# DESIGN STUDY REPORT UPDATE MEMO

MOA Project #19-08

## LOIS DRIVE RECONSTRUCTION BENSON BOULEVARD TO 32ND AVENUE

Figure 1 - Project Location and Vicinity Map

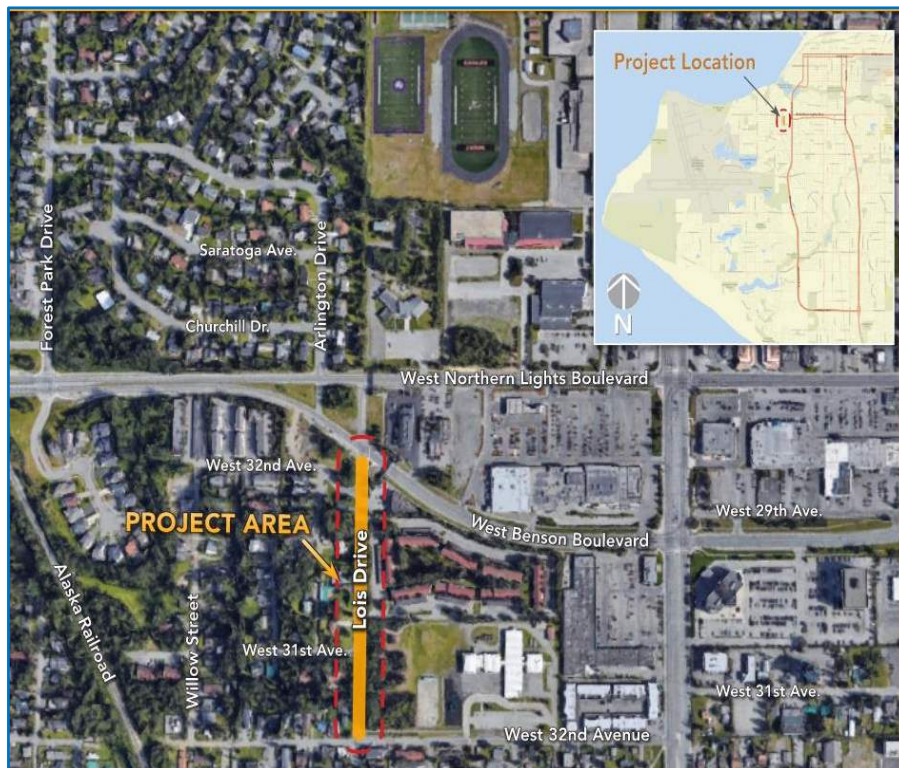
As noted above, the project limits now only include Lois Drive from Benson Boulevard to W. 32<sup>nd</sup> Avenue. W. 32<sup>nd</sup> Avenue, including the intersection of Lois Drive and W. 32<sup>nd</sup> Avenue, have been removed from the project. The new project limits are shown in FIGURE 1. All other aspects of the projects, except as noted below, remain as outlined in the DSR.

Figure 2 – Preferred Roadway Typical Section

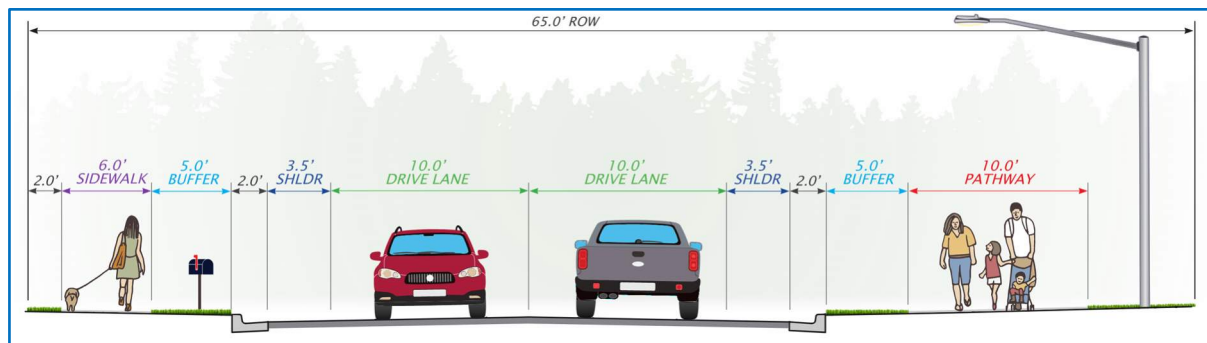
The Lois Drive preferred roadway typical cross-section includes minor changes from the preferred cross section from the approved, Final DSR. Based on recommendations from the traffic department the lane width will be reduced from 11 feet to 10 feet. The 1-foot reduction in lane width on each side will be reallocated to the vegetative buffers (0.5 feet each) and the sidewalk on the west side of the roadway will increase from 5-feet- to 6-feet. The cross-section revisions result in increased snow storage and pedestrian safety. If feasible, the pathway on the east side of the roadway will meander further from the roadway in select locations. The updated preferred roadway typical section is shown below in [FIGURE 2.](#)

The Lois Drive preferred roadway typical cross-section will consist of two, 10-foot travel lanes with 3.5-foot wide shoulders and barrier (Type 1) curb and gutter. A 10-foot wide paved pathway is proposed on the east side of the roadway and a 6-foot wide concrete sidewalk is proposed on the west side of the roadway. The non-motorized facilities would be detached from the back of the curb by 5-feet. Roadway markings will include centerline, stop-bars, and pedestrian crosswalk markings. CRW will investigate traffic calming measures such as speed cushions and radar speed signs during design.

Figure 4 – Intersection Alternative 2

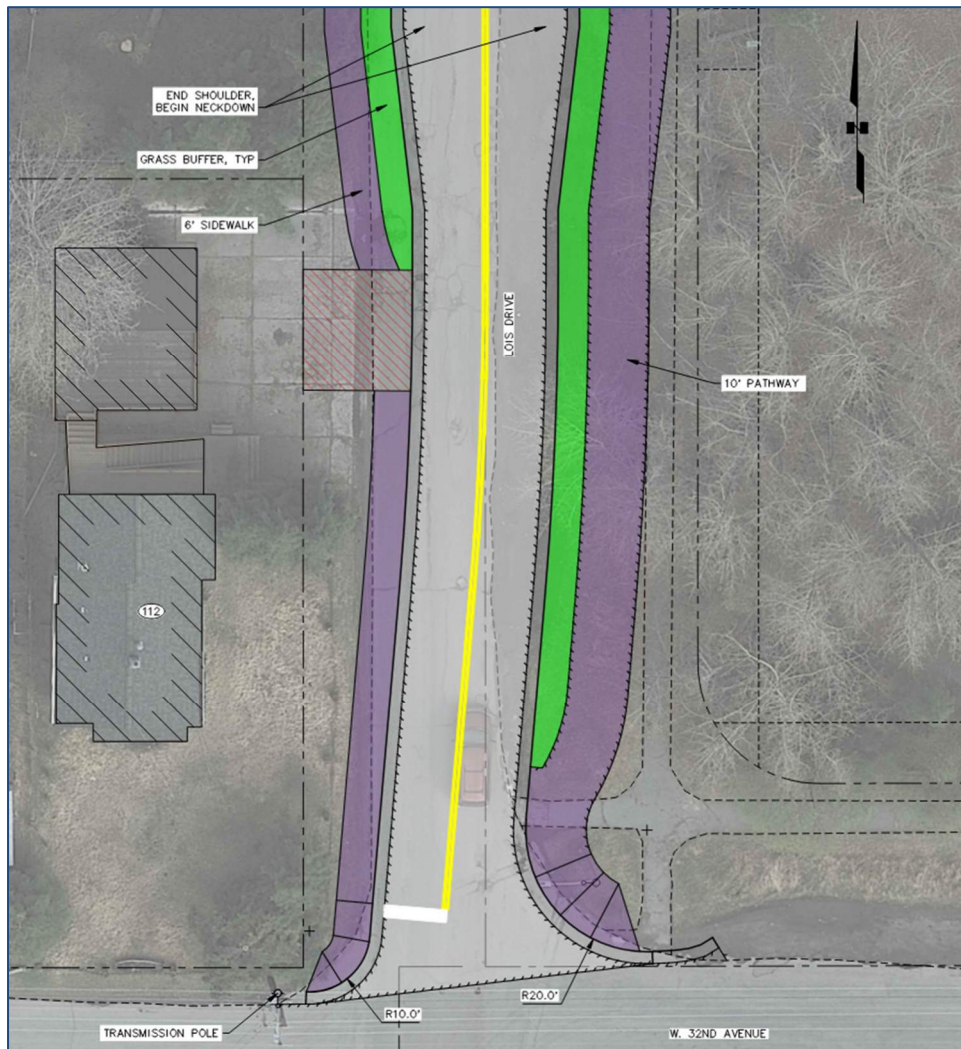
- Pros:
  - No impact on Parcel 112
  - Large transition curve to shift roadway west
  - Avoids impacts to transmission pole
- Cons:
  - Intersects W. 32<sup>nd</sup> Avenue at an 85-degree angle and 5 feet offset to the east
  - West side radius is only 10 feet. The west side return radius is reduced to 10 feet to avoid impacts to the transmission pole
  - The 3.5-foot shoulder terminates north of the point of curvature (PC) of the transition curve

A meeting was held with CRW, PM&E and the Traffic Department to discuss the interim intersection transition alternatives. After weighing the pros and cons, all parties agreed that Intersection Alternative 2 move forward as the preferred alternative. Intersection Alternative 2 avoids relocation of Chugach Electric (CEA) high voltage transmission pole and eliminates the need for ROW acquisition while providing a safe transition to the existing intersection. Due to the skewed roadway alignment and half-lane shift required for this alternative, the Traffic Department requested that the intersection remain as an all-way stop intersection. Curb radii are smaller than MOA Design Criteria Standards, however this results in a safer pedestrian crossing, reducing the distance to cross the intersection.

Intersection Transition Alternative 2 has been identified as the preferred option. The Lois Drive centerline will intersect 32<sup>nd</sup> Avenue at an 85-degree angle and 5 feet offset to the east. The 3.5-foot shoulders will terminate north of Parcel 112 and the roadway will neckdown to stay within the MOA ROW. The west curb return radius will be 10-feet and the east curb return radius will be 20-feet.
